Access Compliance Report

Public Rights-of-Way

(Curb Ramps)

Intersection ID: 2626	Main Street: FAIRVISTA_DR	Cross Street: MOONLIGHT_LN	Location: S
ADA ID: 127864F723F4	Ramp Type: PerpDiag	Initial Pass/Fail: Fail	Overall Compliance: No
Codes/Mitigation Info/Possible Solution		Field Measurements/Component Compliance	
Severity Score: 58.75

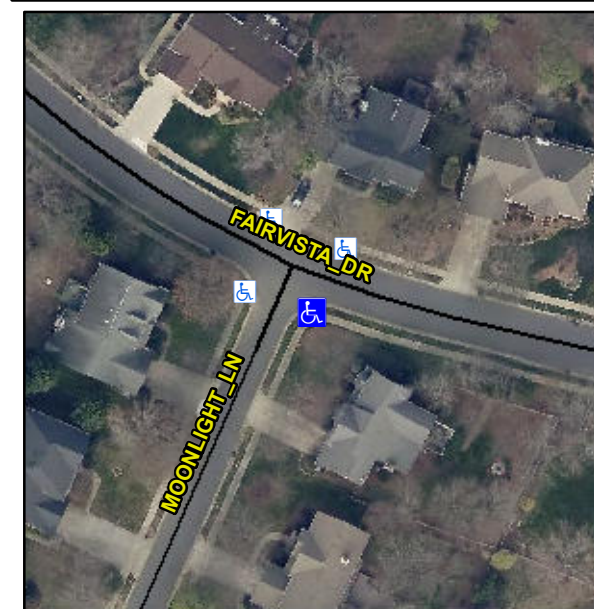
Not Found, R304.5.1, R304.2.2, R304.5.3

Compliance	Description	Data	Compliance	Description	Data
N/A	Ramp Length (in)	47.0	No	Ramp Slope (%)	15.5
No	Ramp Width (in)	40.5	No	Ramp XSlope (%)	8.2
N/A	Flare Type LT	N/A	N/A	Flare Type RT	N/A
N/A	Flare Slope LT (%)	N/A	N/A	Flare Slope RT (%)	N/A
N/A	Flare Traversable LT?	N/A	N/A	Flare Traversable RT?	N/A
N/A	Landing Length (in)	N/A	N/A	DWS Provided?	N/A
N/A	Landing Width (in)	N/A	N/A	DWS Contrast?	N/A
N/A	Landing Slope (%)	N/A	N/A	DWS Length (in)	N/A
N/A	Landing X Slope (%)	N/A	N/A	DWS Full Width?	N/A
N/A	Landing Curb? (Y/N)	N/A	N/A	DWS Offset (in)	N/A
N/A	Shared Landing?	N/A			
N/A	Gutter Ponding?	N/A	N/A	Gutter Slope (%)	N/A
N/A	Gutter Lip Ht (in)	N/A	N/A	Gutter X Slope (%)	N/A
N/A	Painted X Walk1?	No	N/A	Painted X Walk2?	No
	X Walk 1 Direction	To NE		X Walk 2 Direction	To NW
N/A	X Walk 1 Width (in)	N/A	N/A	X Walk 2 Width (in)	N/A
	X Walk 1 Slope (%)	0.5		X Walk 2 Slope (%)	5.9
	X Walk 1 X Slope (%)	7.3		X Walk 2 X Slope (%)	3.4

Remove & Replace Curb Ramp With Two New Directional Ramps or Equivalent.
